1. Herrin Subdivision 2025 Addition; KPB File 2025-049
Johnson Surveying / Nevels
Location: Cloudy Court, Fairway Avenue & Lost Street
Cohoe Area

# Herrin Subdivision 2025 Addition Preliminary Plat

# ITEM #1 - PRELIMINARY PLAT HERRIN SUBDIVISION 2025 ADDITION

KPB File No.	2025-049
Plat Committee Meeting:	April 28, 2025
Applicant / Owner:	James Nevels JR / Kasilof, AK
Surveyor:	Jerry Johnson / Johnson Surveying
General Location:	Cohoe Loop Rd

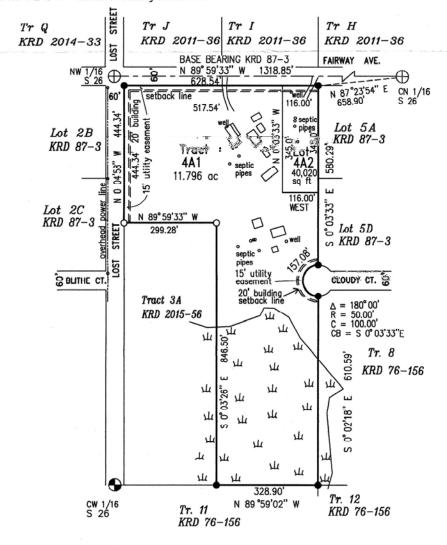
There does not appear to be any encroachment issues to or from the property. **Staff recommends** the surveyor be aware of and watch for any encroachments when doing the field survey and show any encroachments found on the final submittal.

the surveyor rename the wetland correctly to Lakebed per the KWF Wetland Assessment.

A soils report will be required and an engineer will sign the final plat as the new Lot 4A2 is below 200,000 sq ft. There appears to be septic pipes located on Lot 4A2 according to the drawing, if a report previously approved by ADEC can be submitted it may be sufficient.

Add icon for CW 1/16 to legend

Add the KPB No 2025-049 to the title block

Owners is shown as James F. Nevels Jr. per the Assessor Page and CTP, add "F."

Tract to the west needs labeled.

Tract to the southeast needs correct labeling.
